# City of Waupun

TO: Plan Commission Members  
FROM: Mayor, Julie Nickel  
SUBJECT: Plan Commission meeting scheduled for **Wednesday, August 15, 2018, at 4:45 p.m.** in the Council Chambers, City Hall, Waupun.

**From:** Eric Thompson <Ethompson@msa-ps.com>  
**Sent:** Monday, August 6, 2018 8:42 AM  
**To:** Trista Steinbach; Jeff Daane; William Demaa; Kathy Schlieve  
**Subject:** RE: Vande Slunt office (STORMWATER COMMENTS)  
**Attachments:** Meadowview\_School\_Storm Design Exhibit.pdf;  
Meadowview\_School\_Washington\_Avenue\_Storm\_Sewer\_As-Built.pdf

NEW OFFICE BUILDING  
EDWARD JONES INVESTMENTS  
WAUPUN, WISCONSIN  
SITE PLAN, GRADING PLAN AND SPECS

**SITE PLAN**  
SCALE 1" = 20'-0"

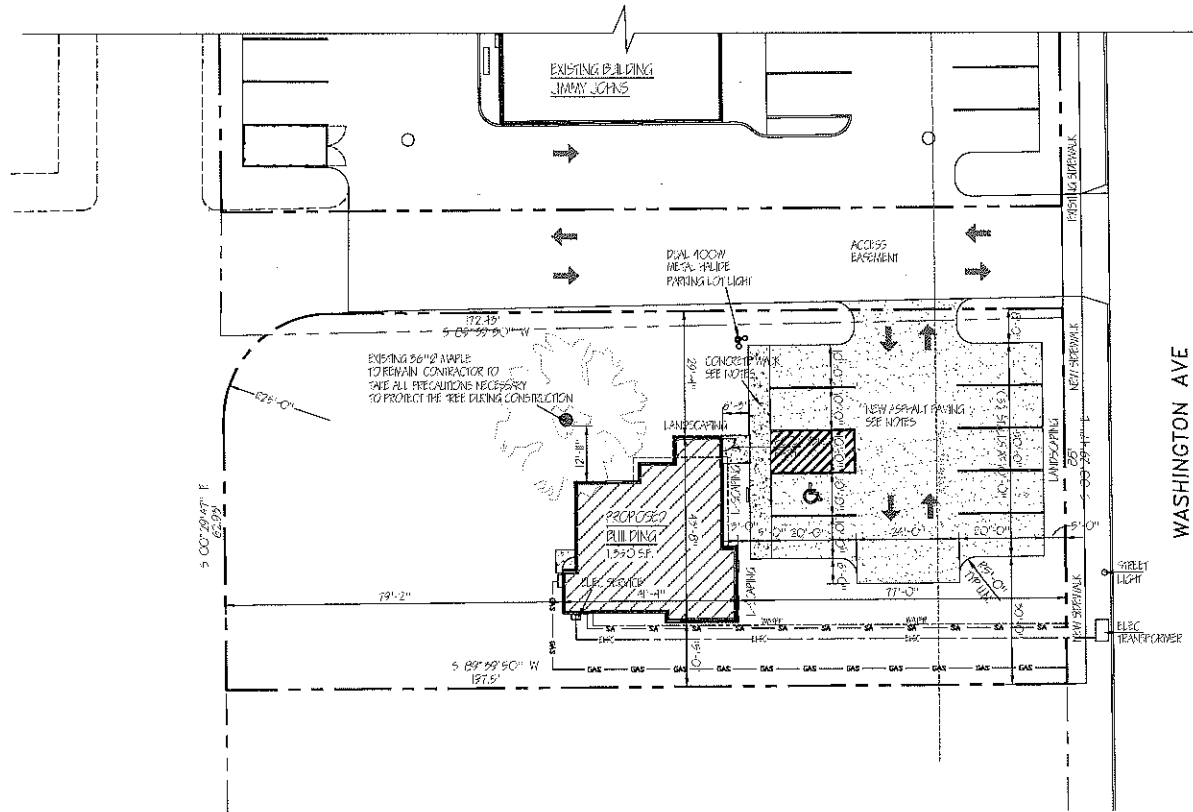
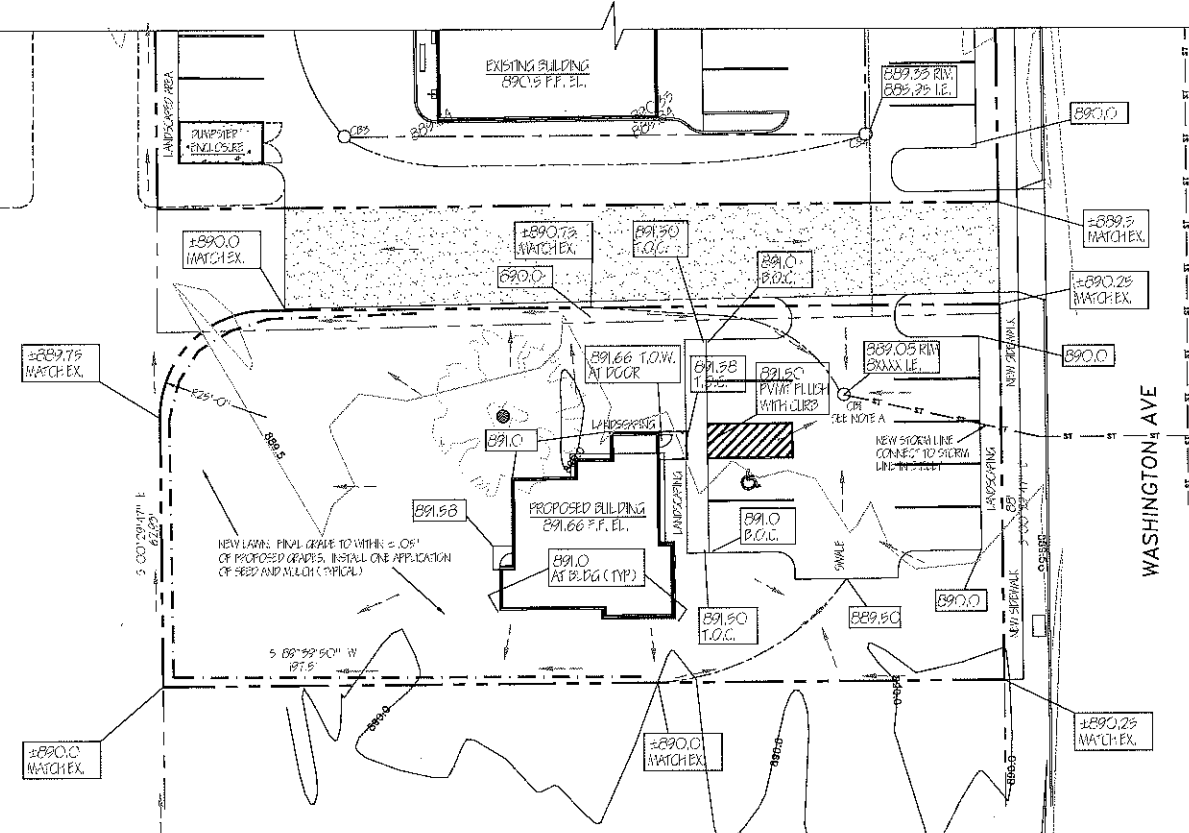
This site is located within the service area of the Meadowview School Pond (see attached). This pond was evaluated as part of the recent stormwater quality master plan and it was found to achieve an 86.5% TSS reduction and a 65.5% TP reduction. The site discharges to Rock River Reach 3 (as defined in the TMDL) which has a requirement of 56% TSS and 87% TP reduction – so the regional pond exceeds reduction requirements but falls short on TP reduction.

An 87% TP reduction is very difficult to achieve without a high degree of infiltration. I quickly evaluated an alternative design whereby their site was reconfigured to have the parking lot drain south to a swale which then connected to the existing inlet in Washington Avenue. Even with a pretty high infiltration rate there isn't enough room/length to get above 56% TP reduction on site. Cumulatively, with the downstream regional pond we'd get more than 56% for this site – but not much more. In the end, it probably isn't worth it to require anything on site based on the limited return vs. the additional complexity and potential extra cost. Regardless, they should be setting up roof drains to flow over pervious areas – as opposed to directly to the parking lot pavement.

Note that the total site area is less than 0.4 acres. This is less than the WDNR's 1-acre review threshold (assuming the whole site would be disturbed) so there will be no post-construction stormwater management requirements for this site other than those required by the City.

On the plans I see that they haven't indicated the size of the storm pipe running towards Washington Avenue. Attached are the as-built drawings for the Washington Avenue. The point they appear to be connecting to is listed as an 18" pipe. Review of recent aerial photos do not show any street inlets at this location, so the whole 18" would appear to be allocated for this site. They should also be proposing an 18" storm sewer then.
